Sub: Strengthening of ICF bogie Frame.

Sub: Bogie Alteration Instructions for BG mainline and self-propelled ICF design coaches.

Sub: Bogie frame strengthening in connection with Bogie frame crack.

ROSD	ASSEMBLY DRAWS	SUPERSEDED BY:	INDIAN RAILWAY STANDARDS
REFERENCE:-	SCALE: D	1:1	MAIN LINE COACHES
	1:2	1:2	STRENGTHENING ARRANGEMENT
			OF ICF COACHES
			U.S. 100/20/17
			B.G. [CG]
			CG-17066

DESIGNED BY		CHECKED BY		DATE	
SUPERSEDED BY		REVISION		REVISION	
INDIAN RAILWAY STANDARDS		MAIN LINE COACHES		MODIFIED BOGIE FRAME	
ARRANGEMENT FOR SG-AC COACHES		B.G.		CG-17066

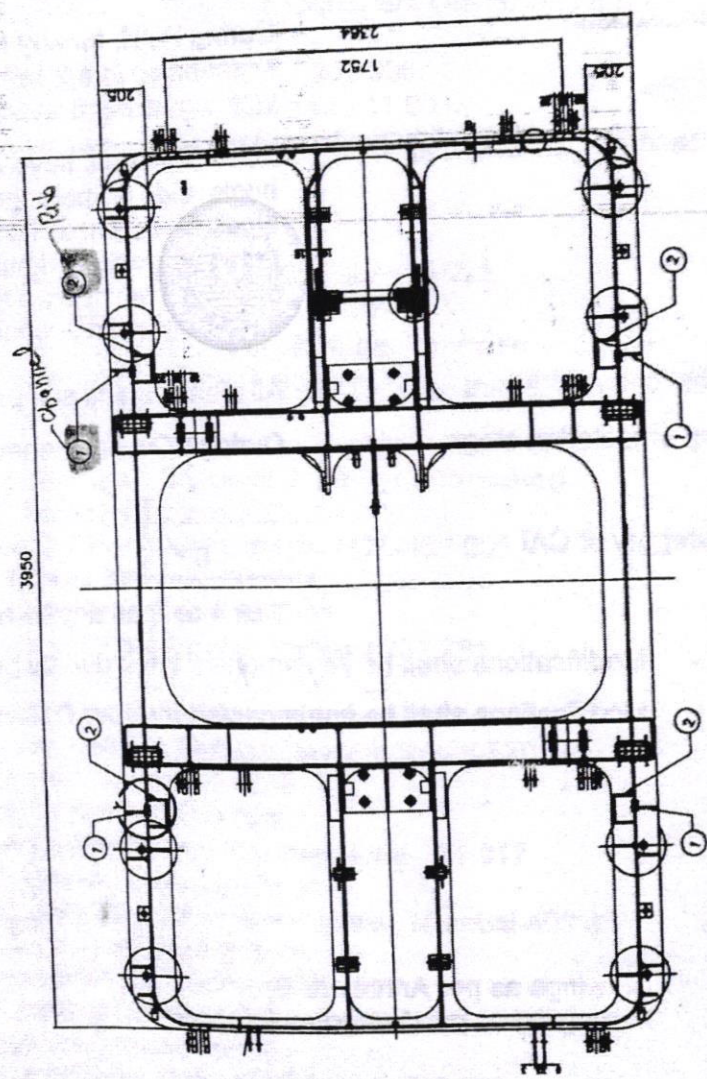
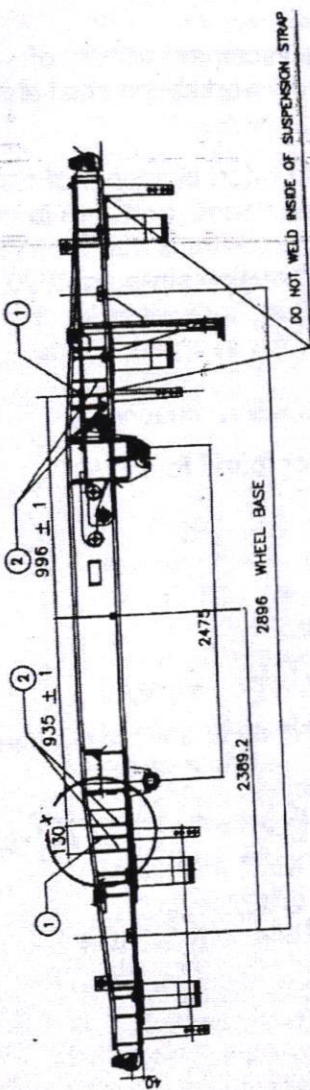
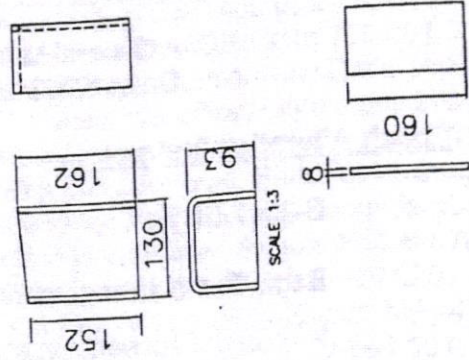
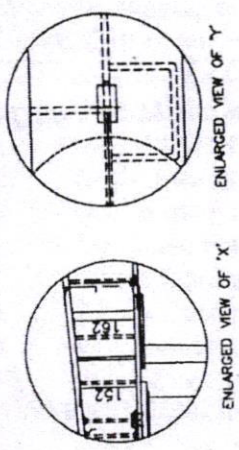
As an additional safeguard, it is suggested that strengthening of bogie frame may be done by providing a channel from inside and a rib from outside (at the centre of inner channel) in the area of inner Axle Guide as per RDSO drawing no. CG - 17066.(copy enclosed). General welding guidelines may be followed as prescribed in RDSO CMI No. RDSO/2012/CG/CMI-02, Amendment 1 issued vide letter No. MC/CRN/REH dated 17.07.2015.

MODIFIED LOCATIONS IN BOGIE FRAME INDICATED WITH 1 & 2

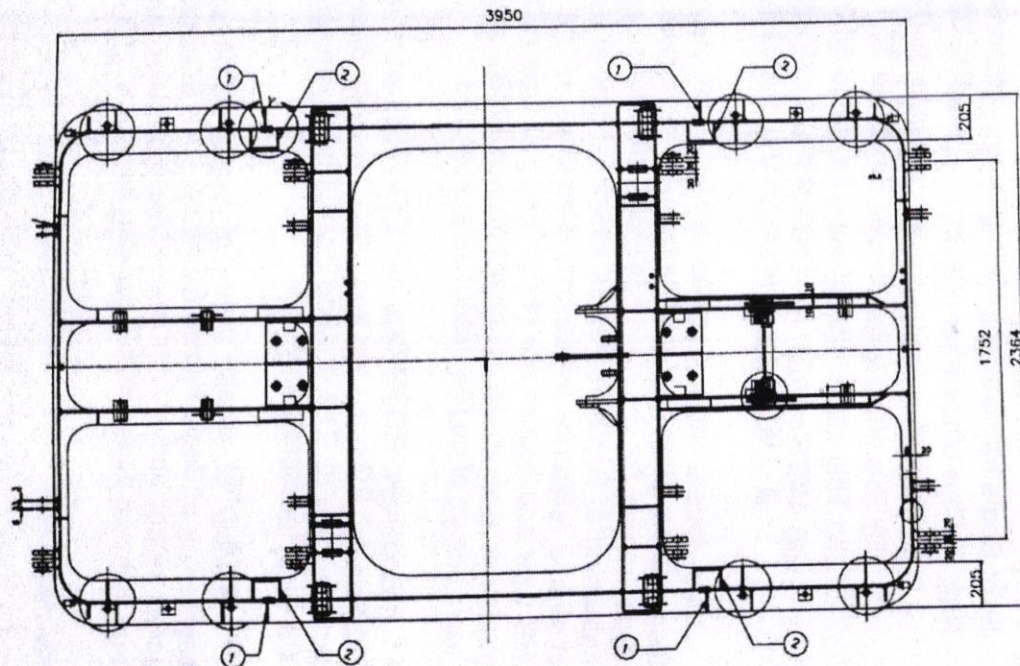
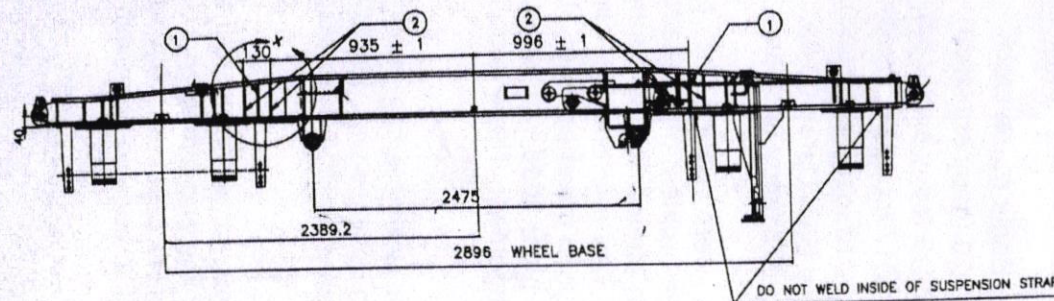
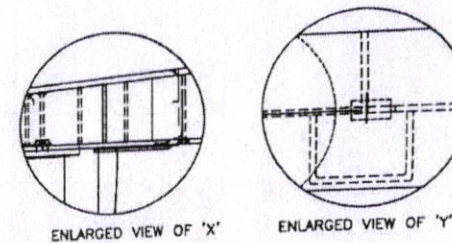
Accordingly, RDSO Drg. No. CG-17066 alt '1' for strengthening of bogie frames for AC/Non-AC BG main line and hybrid type ICF design coaches was issued vide letter under reference (i). The drawing has further been updated as RDSO drawing no. CG-17066 Alt '2' for more clarity.

In view of recent cases of bogie frame crack, it is requested to ensure strengthening of Bogie frames for AC/Non-AC BG main line and hybrid type ICF design coaches as per above mentioned CAIs issued for mainline coaches & hybrid type ICF design coaches as per RDSO drawing no. CG-17066 Alt '2' enclosed herewith.

MODIFIED LOCATIONS IN BOGIE FRAME INDICATED WITH 1 & 2

2	1&2	VSC/	TITLE CHANGED NOTE 2	
		02/22	ADDED NO. OF CHANGED	
			TABLE ADDED	
1	1&2	VSC/	Description of Item 1 & 2	
		04/12	changed in table	
ALT	TECH	ALPHA	DESCRIPTION	DATE
